Architectural Review Board
October 21, 2026

Agenda Item #5
Application 2026-67-CA

Summary of Request:
Construct a single-family dwelling

Applicant (as applicable):
Michael DeCarlo, on behalf of DeCarlo Hawker Architects

EXTERIOR ELEVATIONS - PROPOSED

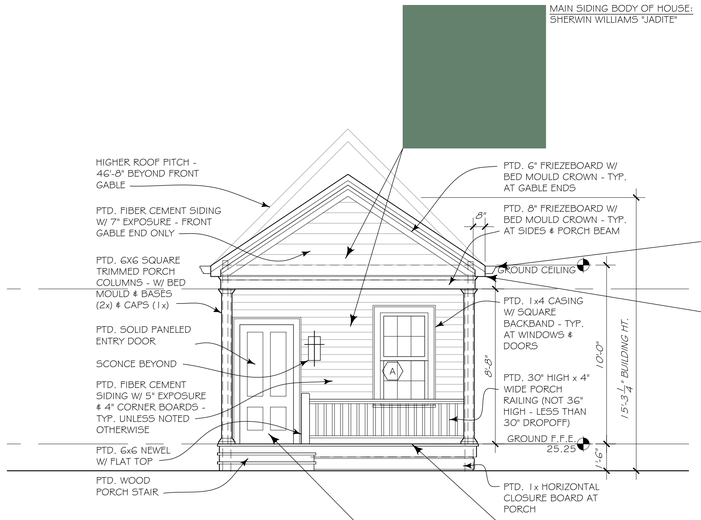
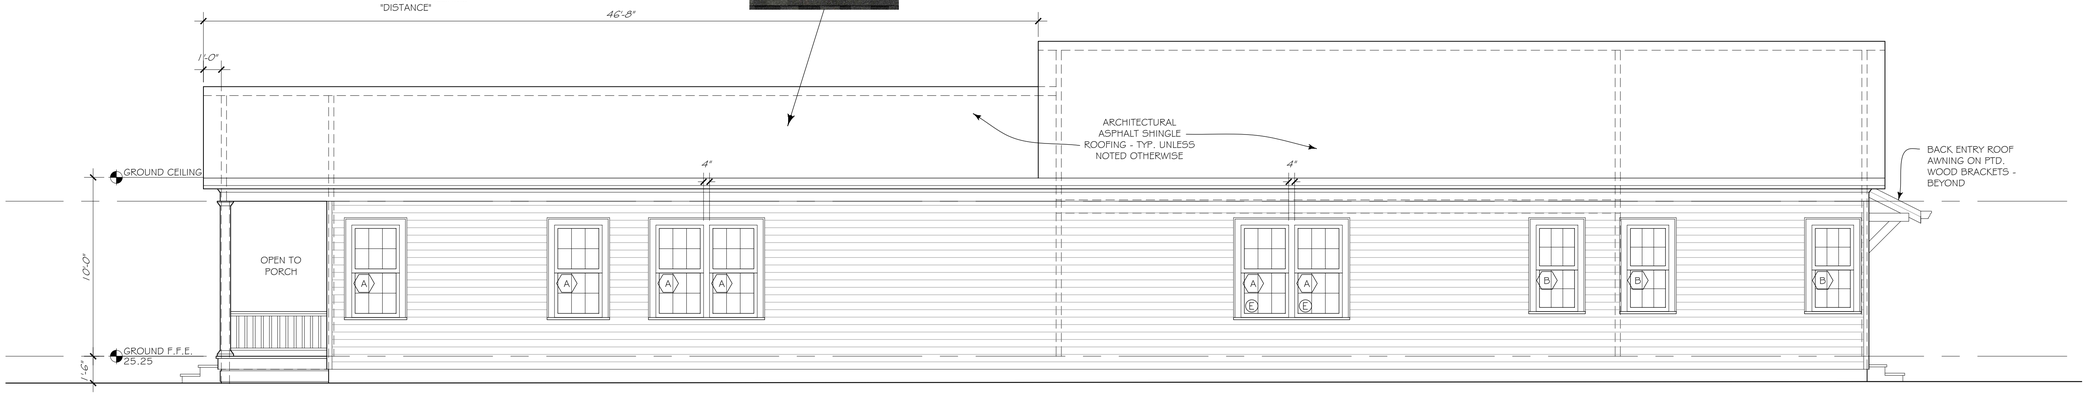
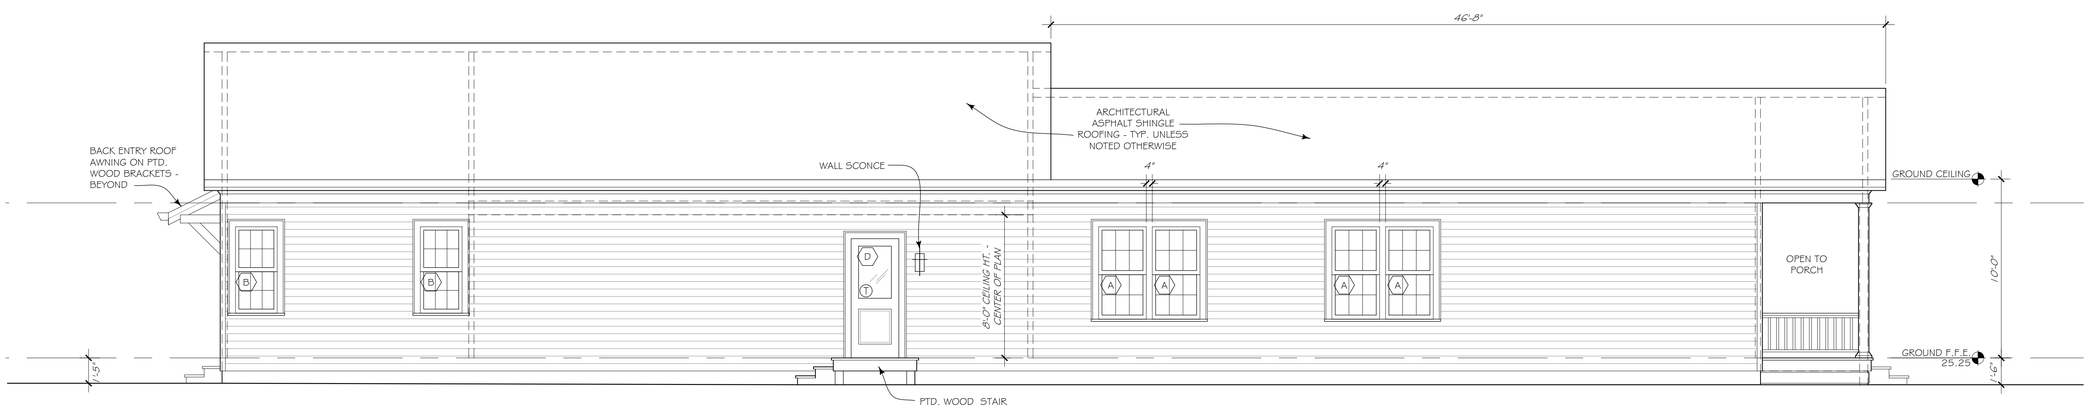
- The proposed slab-on-grade foundation is not compliant with the *Guidelines*. The slab foundation would be elevated to 1'-6". Adjacent shotgun dwellings from 1152 to 1162 Texas Street sit on pier foundations that are approximately 2'-0" in height.
- Apart from the low foundation height, the design is compliant with the *Guidelines* and compatible with the district in terms of its placement, orientation, size, massing, materials, and design.

The slab-on-grade foundation is generally not in keeping with the Oakleigh Garden District, which predominantly features homes on raised pier foundations, which are better suited to Mobile's frequent major rain events. The proposed slab would be elevated 1'-6" above grade, which is preferable to a typical slab, which may only sit 4 to 6 inches above grade. Adjacent shotgun dwellings sit on raised pier foundations that are approximately 2'-0" in height. A similar raised pier foundation would be more in keeping with the district and compliant with the *Guidelines.*
